**Meeting of the Central Valley Flood Protection Board  
July 27, 2012  
Staff Report – Encroachment Permit  
Sacramento Area Flood Control Agency (SAFCA)  
Unionhouse Creek Improvements, Sacramento County**

Consider approval of Permit No. 18777

The applicant proposes to widen the existing concrete-lined bottom of Unionhouse Creek by 8-feet from Franklin Boulevard to Center Parkway; and to concrete line the side slopes of Unionhouse Creek from Center Parkway to Bruceville Road; and relocate an existing City of Sacramento sump pump (Sump No. 201).

**WOOD ROGERS**  
 DEVELOPING INNOVATIVE DESIGN SOLUTIONS  
 3301 C Street, Bldg. 100-B Tel: 916.341.7760  
 Sacramento, CA 95816 Fax: 916.341.7767

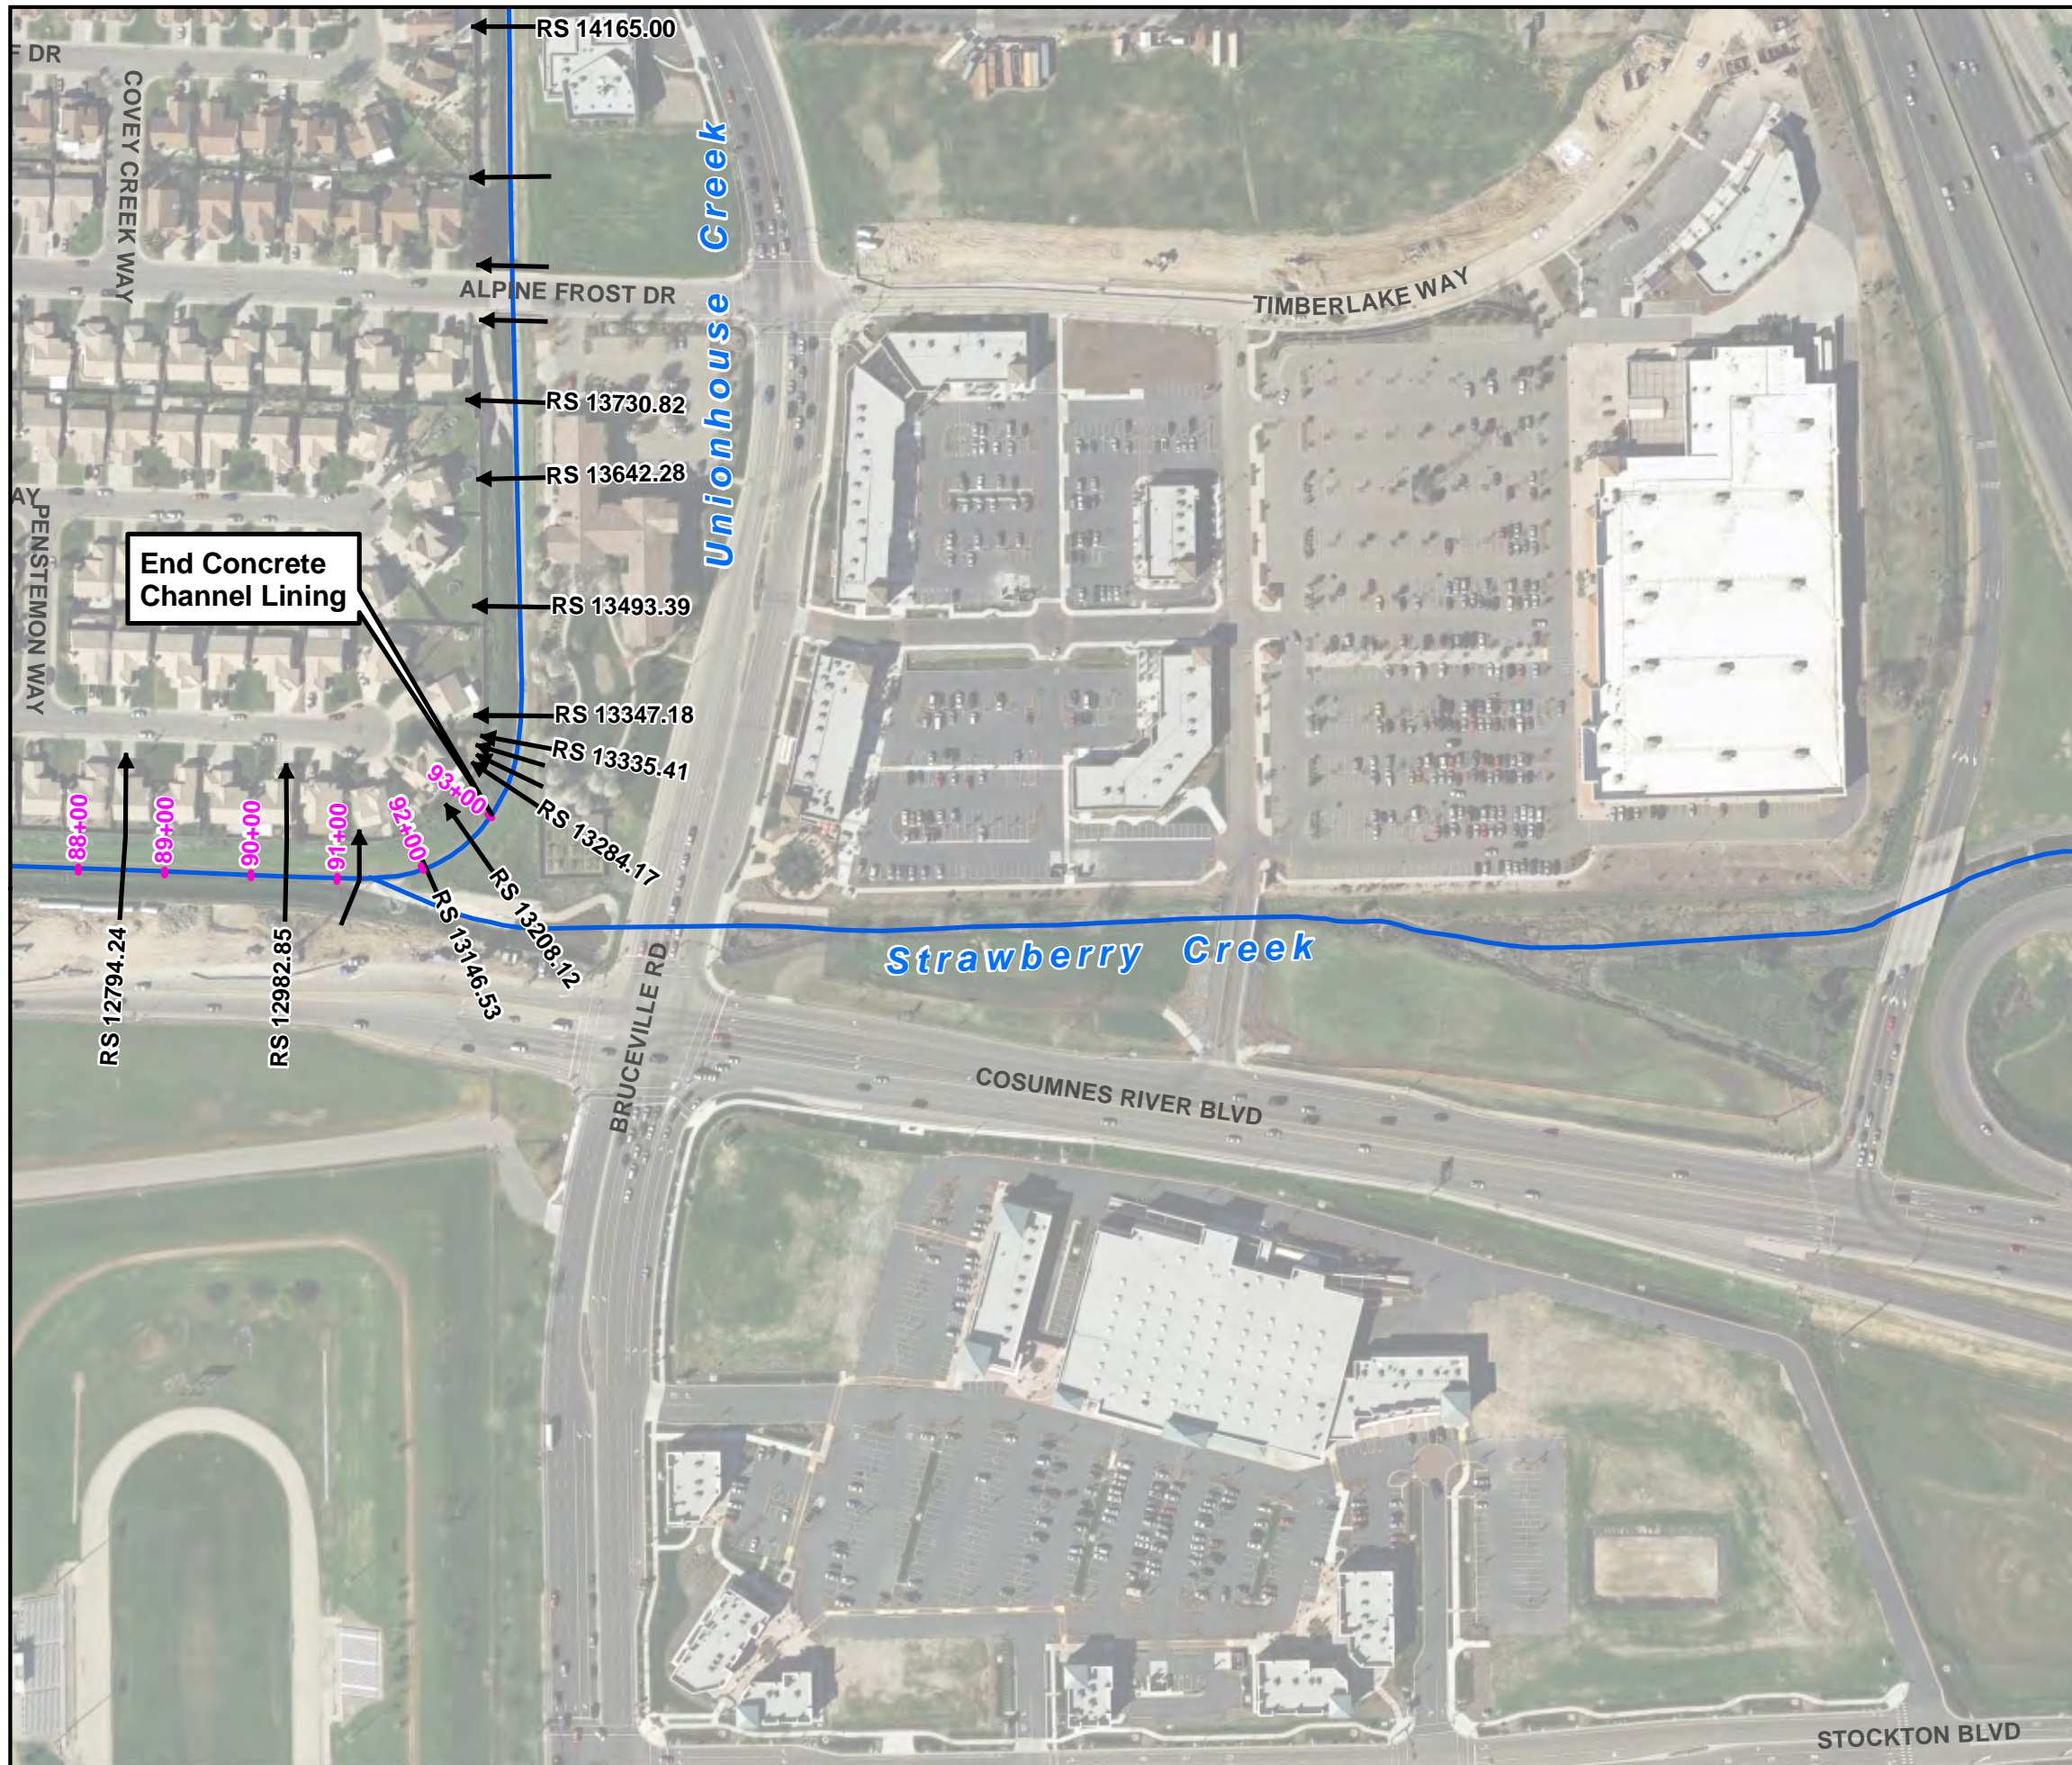
A hydraulic analysis was conducted by Wood Rodgers (WR) in May 2012 to evaluate the design proposed by SAFCA and demonstrate that the 100-year water surface elevation (WSE) would be contained in the new channel conveyance. However, the HEC-RAS model developed by WR did not include any improvements as part of the RT light rail project next to Unionhouse Creek in the analysis. CVFPB staff requested WR to re-run the HEC-RAS model considering the proposed RT light rail improvements and received an updated hydraulic report from WR on July 9, 2012. The results concluded that the proposed RT improvements would elevate the 100-year and 200-year WSE for the existing Unionhouse Creek configuration, noting that with RT's embankment above the 100-year WSE, southerly Unionhouse Creek overland release would no longer flow to Consumnes River Boulevard when additional channel capacity is needed. As a result, both peak flows and WSE's will increase and potentially flow north towards residential development. However, when WR ran the HEC-RAS model including a widened and improved Unionhouse Creek as proposed by SAFCA, the model indicated adequate capacity to contain the 100-year flow, and 200-year flow, with a limited amount freeboard. This limited freeboard is less than 3 feet, 2 feet and 1 foot in many locations, and in some locations it is negative. Attachment C shows the Unionhouse Creek hydraulic profile, cross sections, cross section details, detailed calculated freeboard table, aerial photo graphical freeboard representation and the FEMA 100-year floodplain for this area.

- c. CVFPB staff concludes that a safety factor (i.e.: freeboard) should be incorporated into this project in the near future, because CVFPB staff also concluded that 37% of the proposed project, as currently designed, provides less than 1 foot of freeboard for the adjacent property owners, calculated as follows:
